Program Bulletin

CUSTOMER SATISFACTION PROGRAM

SUBJECT: Driver Airbag Inspection

MODELS: 2012 Buick Verano
2011-2012 Chevrolet Volt
2012 Chevrolet Camaro, Sonic

2760232

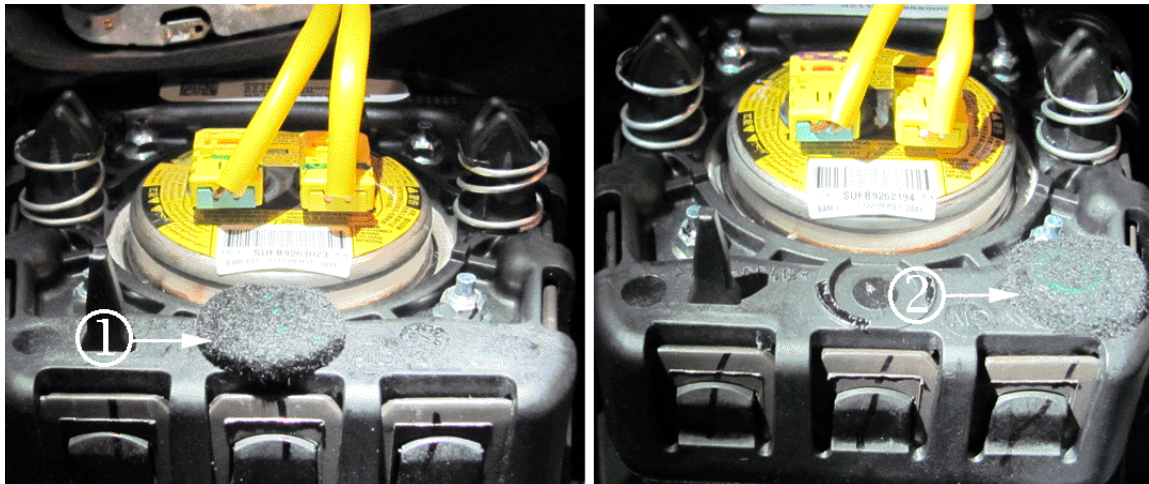
1. Disable the supplemental inflatable restraint (SIR) system. Refer to *SIR Disabling and Enabling* in SI.
2. Turn steering wheel 180 degrees to access the module release points on top of the column.
3. Insert suitable tools to the openings on both sides of the steering wheel.
4. Release the springs in direction of the arrows.

5. Remove the felt patch from the 6 o'clock position (1) and re-install it in the 5 o'clock position (2) as shown in illustration. The felt patch edge should be in line with the edge of the airbag module. The felt patch should not hang over the airbag module edge.
6. Align the steering wheel module fasteners to the steering column fastener holes.
